Access Compliance Report

Public Rights-of-Way (Curb Ramps)

Intersection ID: 3062	Main Street: LOGANVILLE_DR	Cross Street: BENFIELD_RD	Location:	N
ADA ID: 7CDA017DE7EA	Ramp Type: Directional1	Initial Pass/Fail: Fail	Overall Compliance: No	Severity Score: 12.5
Codes/Mitigation Info/Possible Solution		Field Measurements/Component Compliance

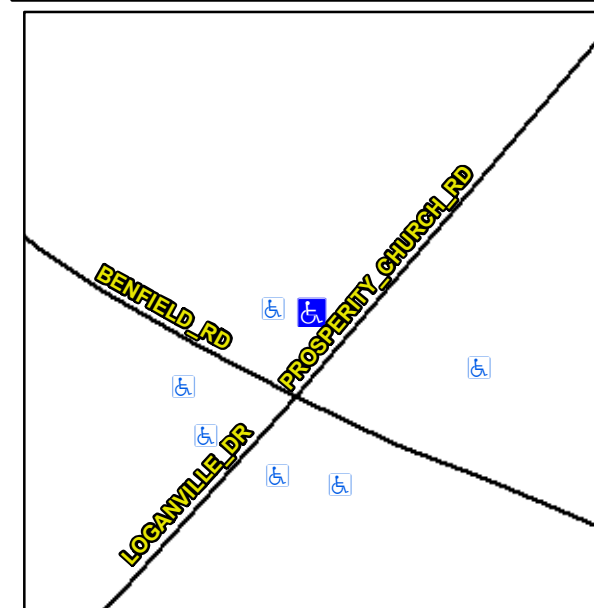
VEGETATION OVERGROWTH

R304.5.3

Compliance	Description	Data	Compliance	Description	Data
N/A	Ramp Length (in)	50.0	N/A	Grade Break?	N/A
Yes	Ramp Width (in)	71.0	N/A	Grade Break Slope (%)	0.0
Yes	Ramp Slope (%)	3.5	N/A	Grade Break XSlope (%)	0.0
No	Ramp XSlope (%)	5.5			
N/A	Flare Type LT	N/A	N/A	Flare Type RT	N/A
N/A	Flare Slope LT (%)	N/A	N/A	Flare Slope RT (%)	0.0
N/A	Flare Traversable LT?	N/A	N/A	Flare Traversable RT?	N/A
N/A	Landing Length (in)	0.0	N/A	DWS Provided?	N/A
N/A	Landing Width (in)	0.0	N/A	DWS Contrast?	N/A
N/A	Landing Slope (%)	0.0	N/A	DWS Length (in)	N/A
N/A	Landing X Slope (%)	0.0	N/A	DWS Full Width?	N/A
N/A	Landing Curb? (Y/N)	N/A	N/A	DWS Offset LT (in)	N/A
N/A	Shared Landing?	N/A	N/A	DWS Offset RT (in)	N/A
N/A	Gutter Ponding?	0.0	N/A	Gutter Slope (%)	N/A
N/A	Gutter Lip Ht (in)	0.0	N/A	Gutter X Slope (%)	N/A
N/A	Painted X Walk1?	Yes		Road Slope (%)	0.2
	X Walk 1 Direction	To E		Road X Slope (%)	2.1
	X Walk 1 Width (in)	119.0		Clear Space?	N/A

Remove & Replace Entire Ramp.
